TECH TIPS TO HELP YOU AT THE SHOP BENCH

A604, A404 Series: AXLE SEAL UPDATE

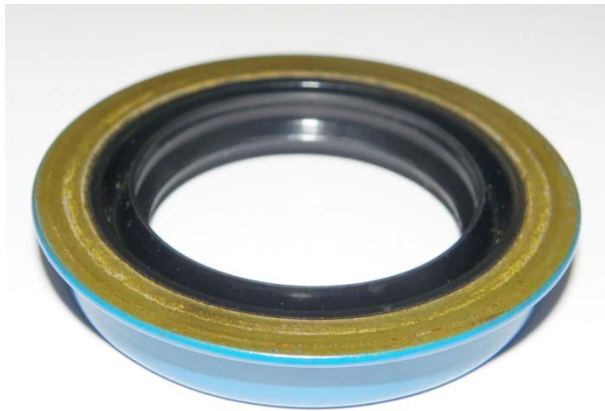
The axle metal clad seal was updated to the latest Chrysler design back in 2004. Chrysler made changes to this construction to accommodate the late 2004-UP vehicles, as the axle seal pocket in the case/extension housing and bearing had changed as well. Use of the earlier design seal in these late models will cause the seal to not seat properly and leak. The new design in these kits fits all, PI # 32366.
